SERVICE BULLETIN

Ref: SRV - 016- 004

Product: Honey Bee AirFLEX tables model year 2014, 15 and 16

Re: Bearing clamp bolts

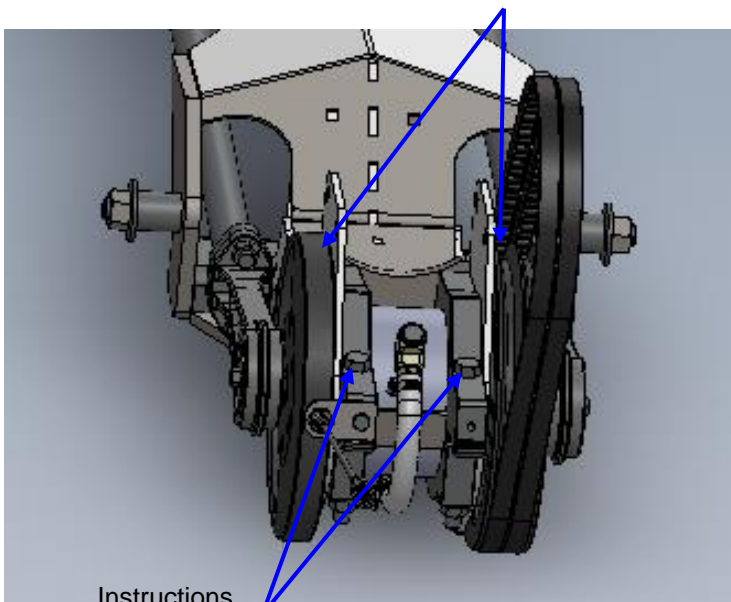
Problem: Std. torque on bearing clamp bolts is inadequate, bearing and flywheel assembly will slide and contact housing. The contact will cause **FIRE**.

Remove the 2 – ½ x 5 ½” gr. 5 unc. bolts. Replace bolts with 2 – ½ x 5 ½” gr. 8 unc.

Solution: Remove gr. 5 bolts and reinstall gr. 8 bolts, torque to 120ft.lb. (Note: If gr. 8 bolts are not available torque existing bolt to 120 ft.lb.).

Important: After torqueing bolts make certain flywheels are not making contact with any part of the housing as they rotate.

Torque bolts to 120 ft.lb.

Note: If gr. 8 bolts are not available torque existing bolt to 120 ft.lb.
